PLANS FOR CONSTRUCTION OF SANITARY SEWERS, STORM SEWERS, WATER MAINS, PAVEMENT AND GRADING FOR LAKESIDE ESTATES

A TRACT OF LAND BEING PART OF THE SOUTHWEST QUARTER AND THE SOUTHEAST QUARTER OF SECTION 20, TOWNSHIP 47 NORTH, RANGE 3 EAST OF THE FIFTH PRINCIPAL MERIDIAN ST. CHARLES COUNTY, MISSOURI

FEB. 10, 1995
DATE
89-3094C
PROJECT NUMBER
1 OF 11
SHEET OF
3094CCON.DWG
FILE NAME
JOP RLF
DRAWN CHECKED

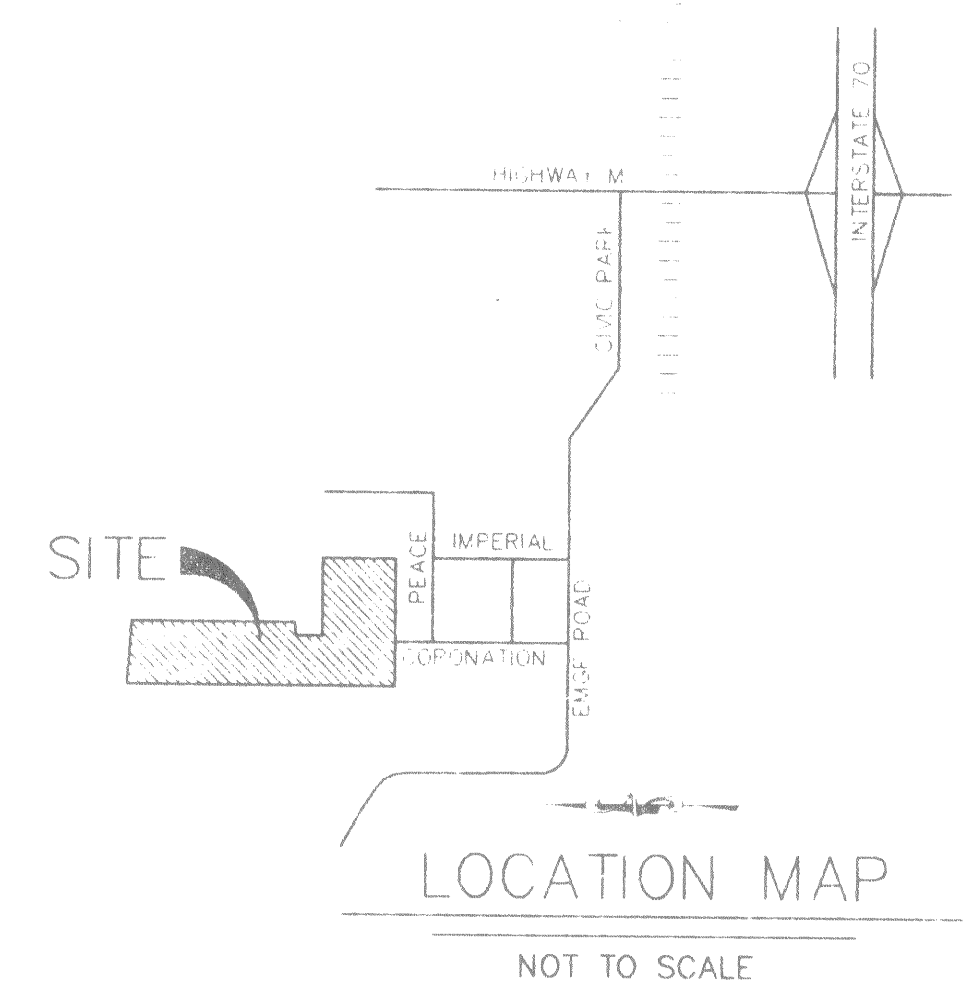
Jim King
4-20-95
Need soils report for roadway
on Blottel property
